SCADA UPGRADE PROJECT

City of Dyersburg

ADDENDUM NO. 1

ISSUE DATE: May 1, 2025

11.01

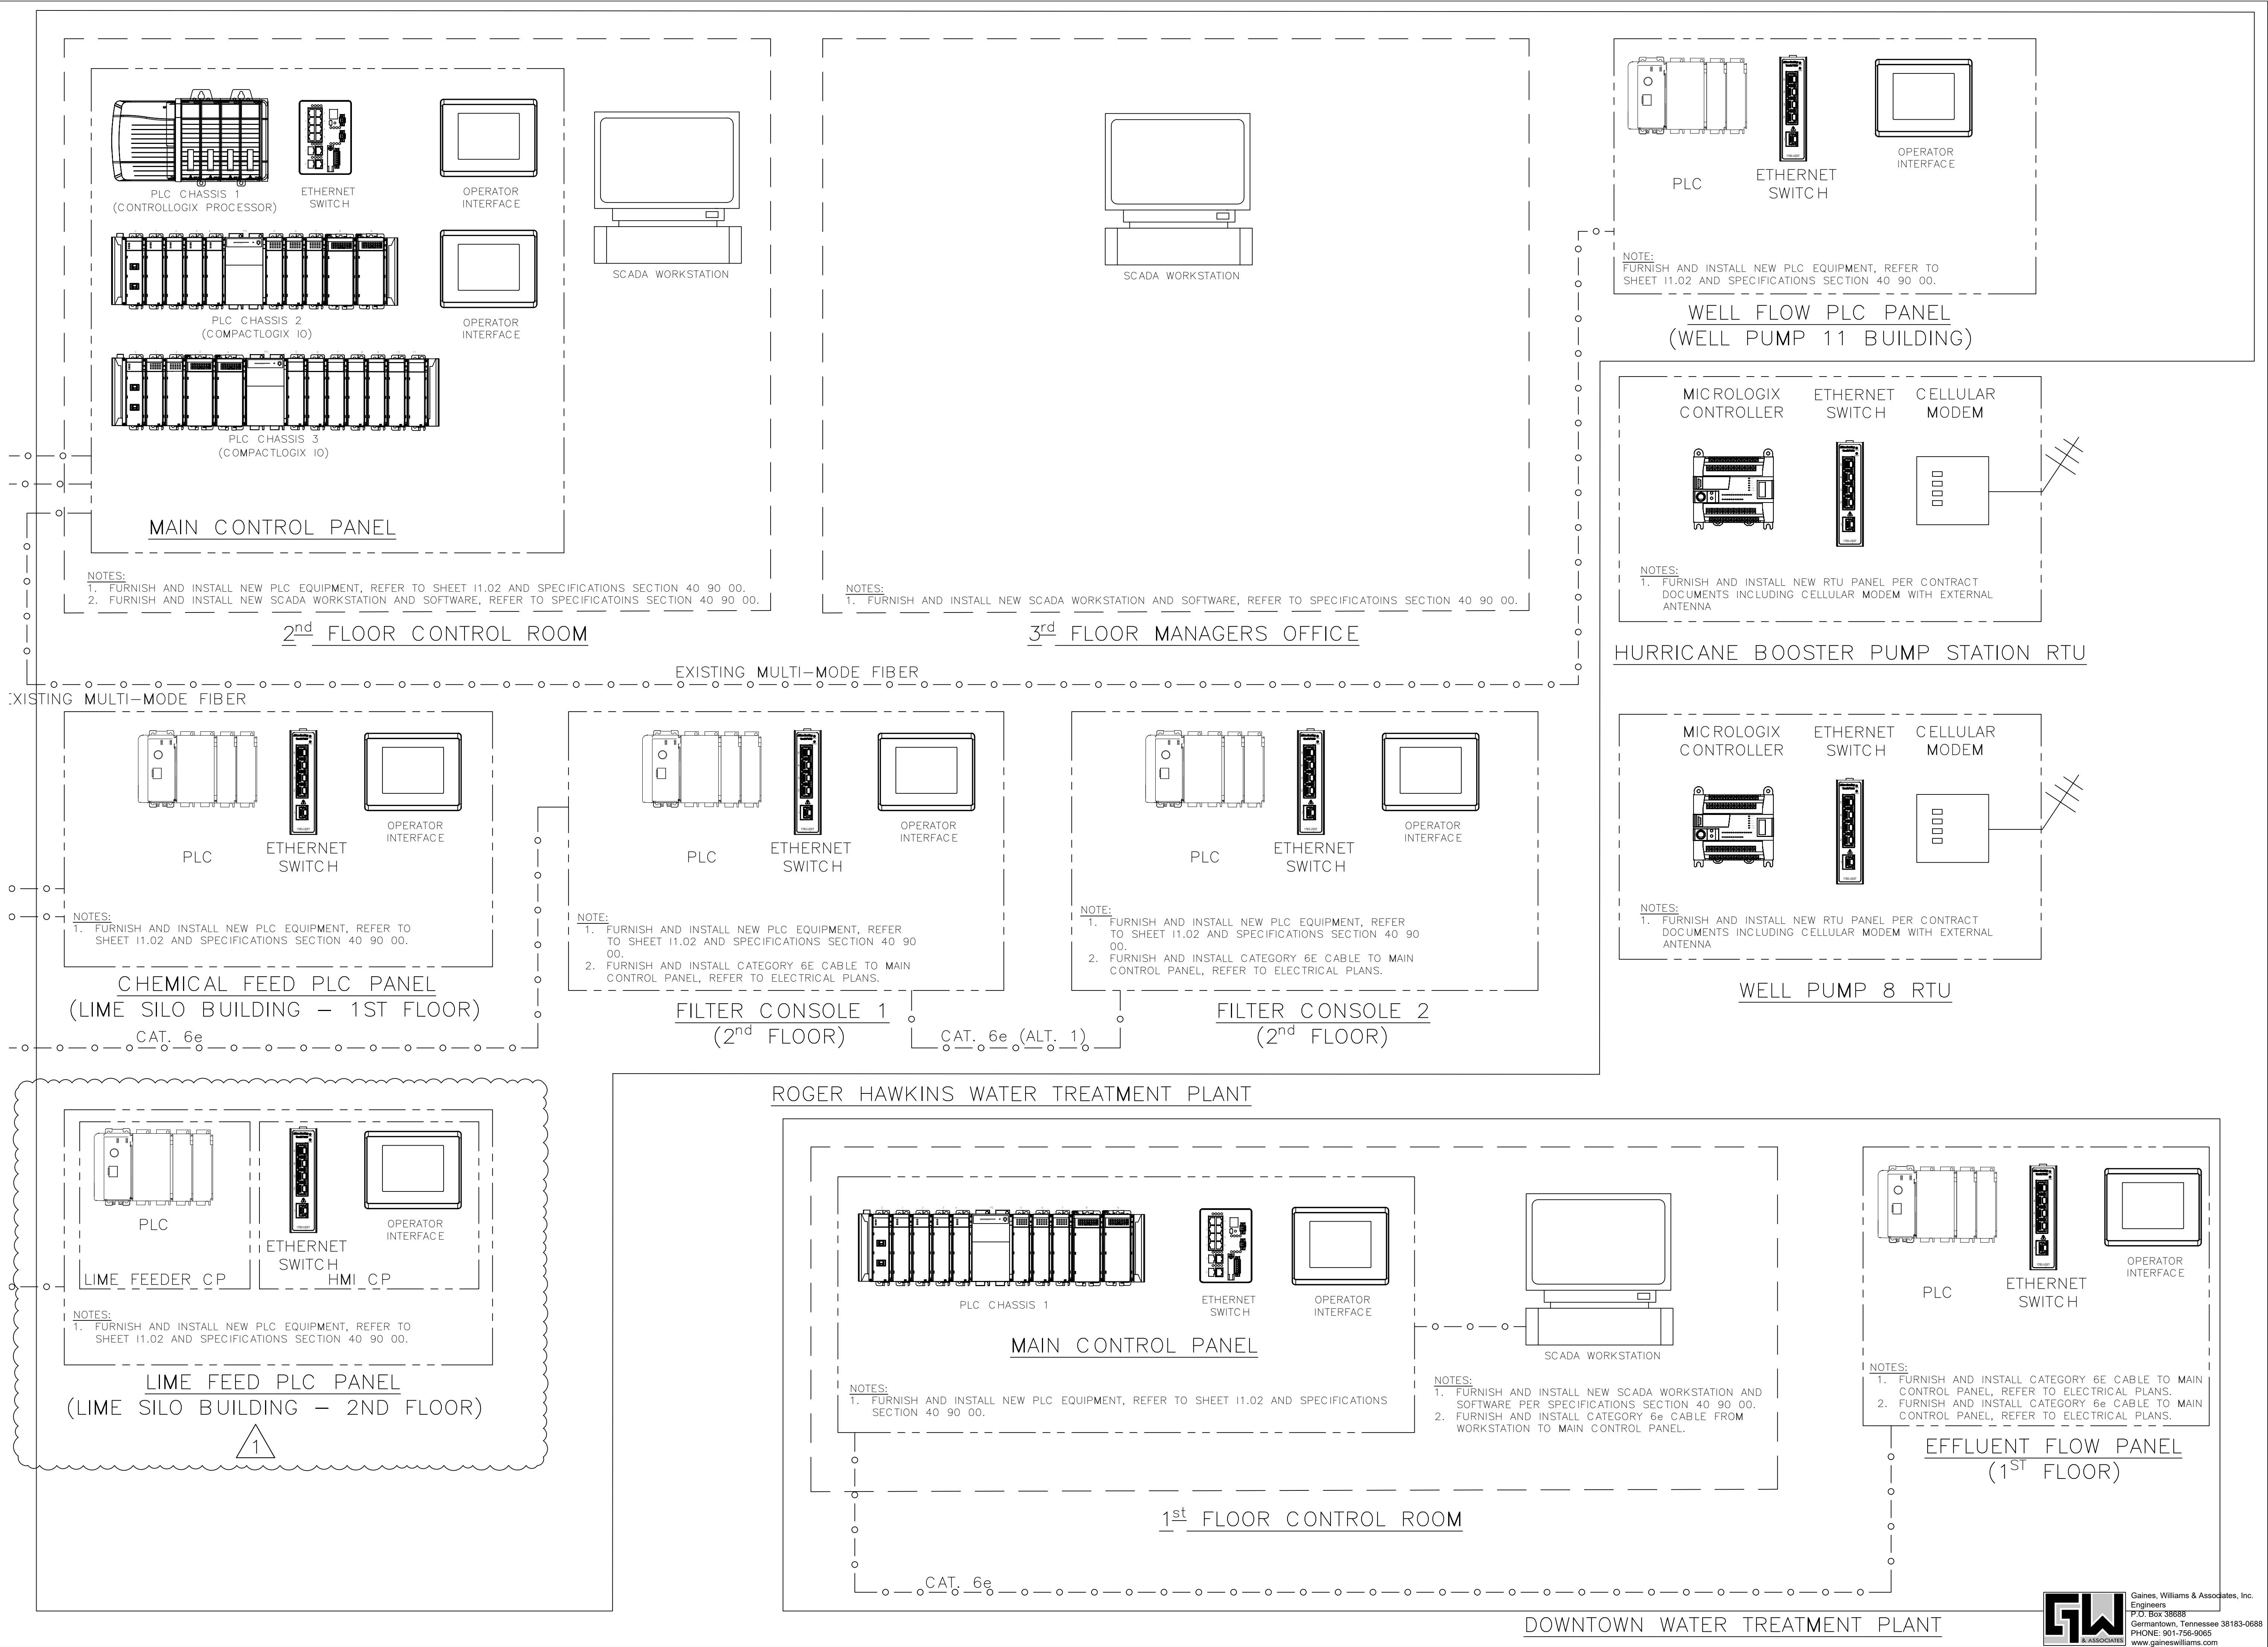
Addendum Item	Page or Drawing	Location and Description of Change
3	Section 40 90 00 1.01.B.8	Refer to specifications, Division 40 90 00, paragraph 1.01.B.8 and add the following: The new PLC programs shall be fully documented, no existing documented PLC programs exist. The contractor shall furnish record programs fully documented in the editable programming software format with no password protection.
4	Section 40 90 00 2.06.B.4	Refer to specifications, Division 40 90 00, paragraph 2.06.B.4 and modify to read as follows: 64 GB:2 X 32 GB, DDR5
5	Section 40 90 00 2.07.A	Refer to specifications, Division 40 90 00, paragraph 2.07.A, add sub-paragraphs 3 and 4. follows: 2.07.A.3. One (1) license of Rockwell Software FactoryTalk Linx Classic. 2.07.A.4. One (1) license of Smartsights WIN-911 Pro with mobile app an email notification and three (3) years customer care plan.
6	Drawing I1.01	Refer to drawing I1.01, Revision 1, added Lime Feed PLC and OI replacement.

REVISIONS	DATE	DESCRIPTION
1	04/28/25	ADDED LIME FEED PLC & OI

DATE	MAY 2024
PROJECT STATUS	BID SET
SHEET NUMBER	11.16

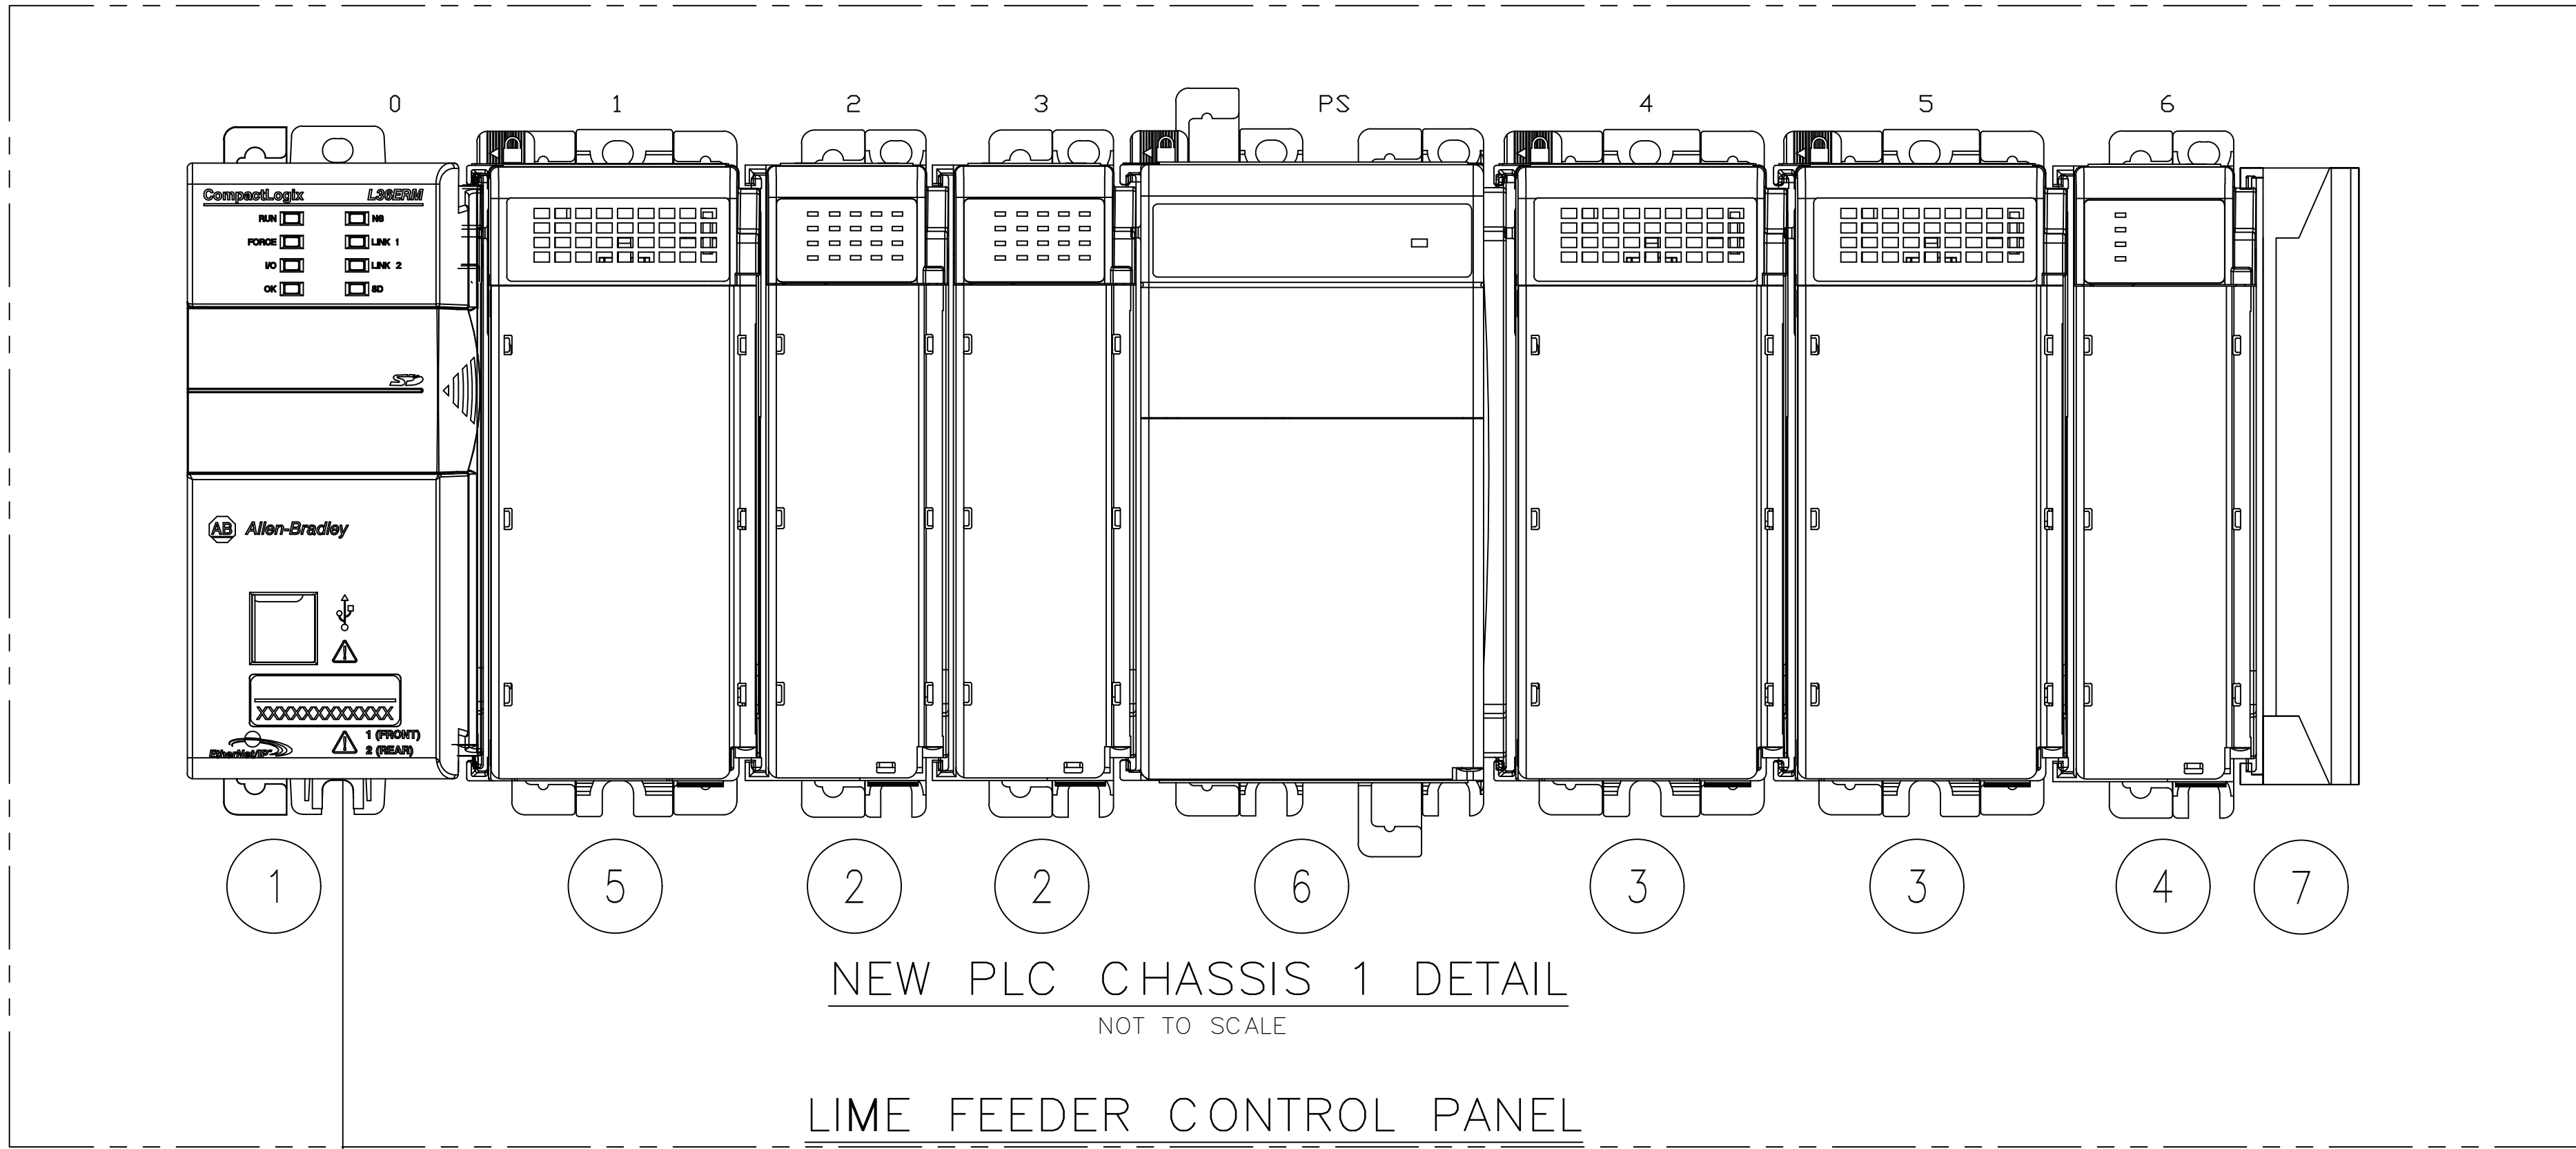
7	Drawing I1.02	Refer to drawing I1.02, Item 16 in Main PLC Panel Bill of materials, revise description and part number as follows: ALLEN-BRADLEY STRATIX 5200 MANAGED SWITCH, FULL CISCO SOFTWARE, 8 – 100/1000 ETHERNET COPPER PORTS, 2 COMBO 100/1000 PORTS, FULL FW, part number 1783-CMS10P.
8	Drawing I1.16	Add drawing I1.16.
9	Drawing I1.08 and I1.12	Refer to drawings I1.08 and I1.12, add the following note: Control panels shall be fabricated per the contract documents including layout, wire numbers, terminal numbers, etc.
10	Section 40 90 00 2.01	Refer to specifications, Division 40 90 00, paragraph 2.01, add the following sentence: The contractor shall include the cost of programming and integration in the bid.
11	Drawing G0.1	Add the following General Note: The maximum outage time for DWTP is 24 hrs. The maximum outage time for RHWTP is 8hrs.

REVISIONS		ADDED LIME FEED PLC & OI	
REV	DATE	DESCRIPTION	
1	04/28/25
